SUBJECT: MILLSTONE POWER STATION, UNIT NO. 3 – ISSUANCE OF AMENDMENT
NO. 288 RE: REVISION TO APPLICABILITY TERM FOR REACTOR COOLANT
SYSTEM HEATUP AND COOLDOWN PRESSURE-TEMPERATURE
LIMITATIONS FIGURES (EPID L-2023-LLA-0009)

Amendment No. 288
Renewed License No. NPF-49

SAFETY EVALUATION BY THE OFFICE OF NUCLEAR REACTOR REGULATION

Figure 3.4-2

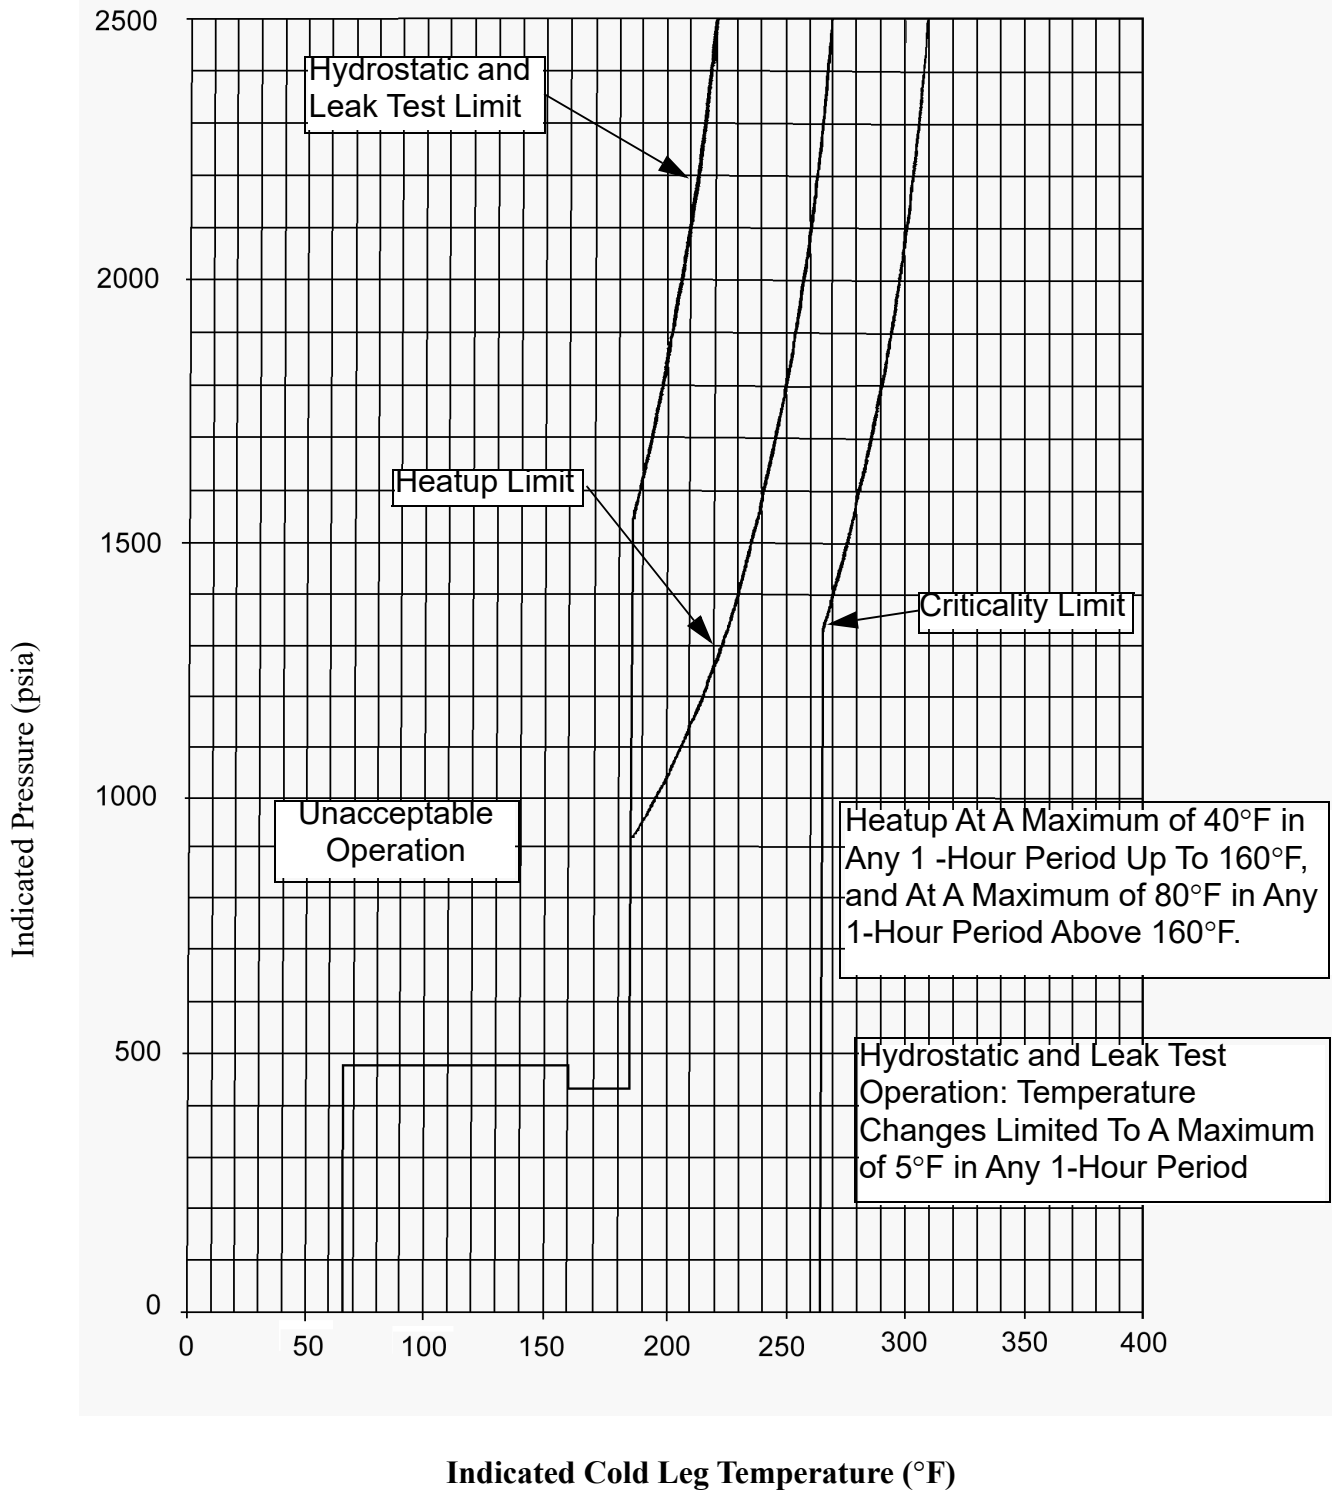
- Figure 3.4-2, MILLSTONE 3 REACTOR COOLANT SYSTEM, Heatup Limitations for Fluence up to **2.72** ~~4.97E+19 n/cm² (32-EFPY)~~ (**54 EFPY**).
- Figure 3.4-3, MILLSTONE 3 REACTOR COOLANT SYSTEM, Cooldown Limitations for Fluence up to **2.72** ~~4.97E+19 n/cm² (32-EFPY)~~ (**54 EFPY**).

- The administrative change corrects a typographical error from “cm” to “cm²” to reflect the standard units for fluence.
- The proposed change corrects a typographical error to reflect the standard symbol for degrees Fahrenheit (°F) in the x-axis of TS Figures 3.4-2 and 3.4-3 as follows:
 - Indicated Cold Leg Temperature (×°F)

Heatup Limitations for Fluence up to $2.72E+19$ n/cm² (54 EFPY)
